Reference: REQ2026-135895

Request for Information – Kangaroo Bay Hotel Major Project

Attachment 1 – Summary of aspects and deficiencies with technical reports

Snip 1. Current CFT cross section, showing 3m wide shared path with raised edge/wall barriers.

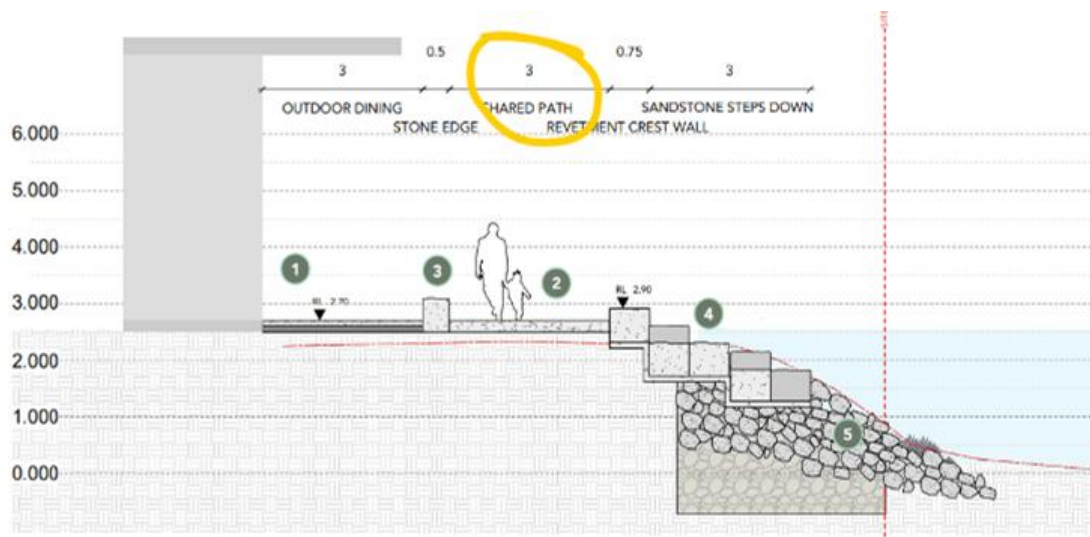
- The design is currently showing a 3.0m wide shared use path which is a continuation of the existing CFT width and format (see snip 1 below). The design has both sides of the shared path bound by low walls or sandstone blockwork, essentially containing CFT users to the path. These edges area a pedal clipping hazard for cyclists and to avoid they will travel more central on the path. Best practice we now apply to any new works on the CFT is provide at least a 500mm offset for any raised edges or obstructions on edges of the trail. While existing sections of the CFT are 3.0m, we would recommend if the current cross section design is to be retained, the shared path should be at least 4m wide.

- There are several points where cross-movement will occur across the CFT, especially from the hotel to the lookout point and viewing decks. Every cross movement is a risk for collision with cyclists, exacerbated by the edge containment reducing opportunity to avoid by moving off the path or tracking close to the edge. The curve of the path, especially around the south side as well as proposed planting areas (screening shrubs) will likely shorten sight lines. The design currently relies on users managing their own risk - cyclists slowing and pedestrians being aware of their surroundings. This is unlikely to eliminate conflict, especially during peak use times.

Snip 2. Predicted cyclist movement (red line) to avoid conflicted area along foreshore.

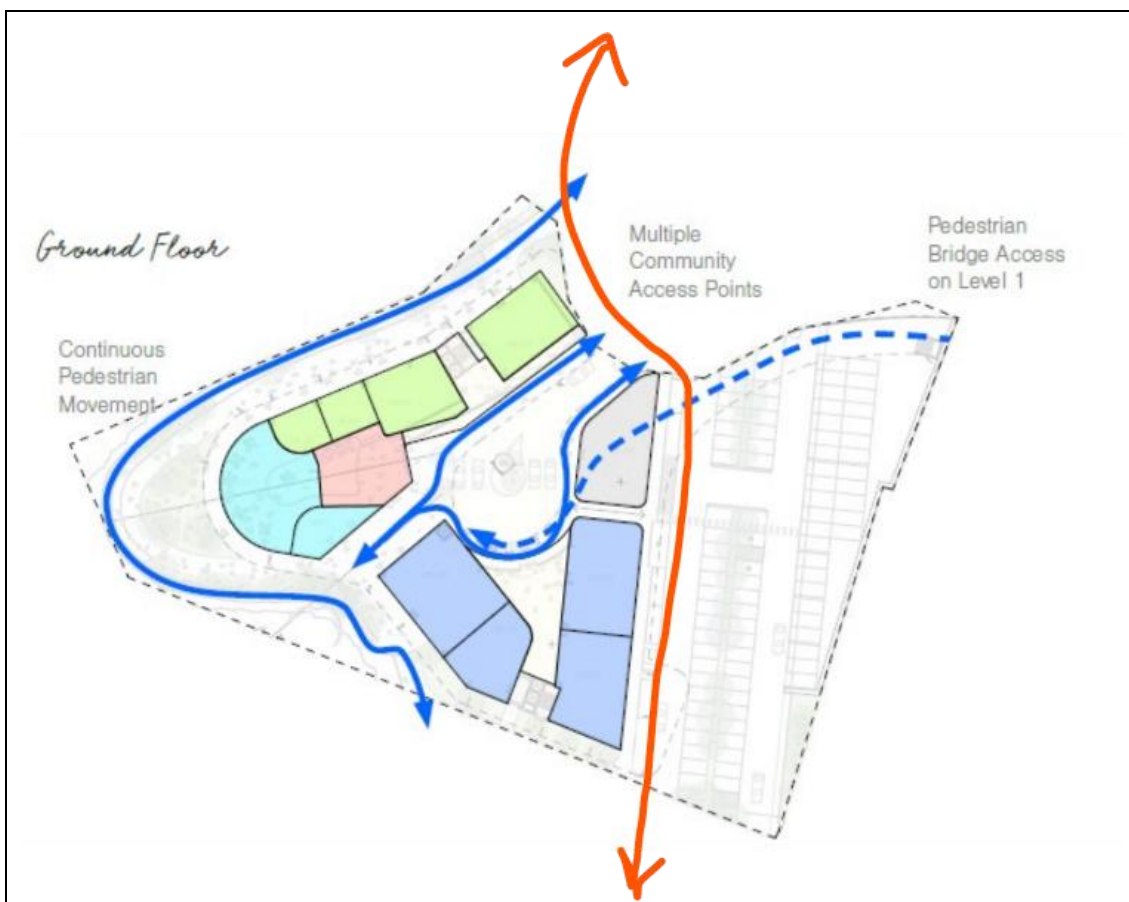
- Given the current layout, it is predicted confident cyclists will avoid the CFT on the foreshore and will instead divert to on-road passage behind the Hotel and through the rear car park (see snip 2 below). This cycle movement is currently not accommodated and introduces a new range of possible conflicts between cars, pedestrians and loading bays.

- It is acknowledged this section of the CFT will be privately owned and managed and therefore liability for these risks rest with the Hotel. However, it is foreseeable that the public will view this section of the CFT as Council responsibility and raise requests regarding conflicts we have no capacity to

address. For this reason, it is critical these foreseeable conflicts are resolved at the design stage.
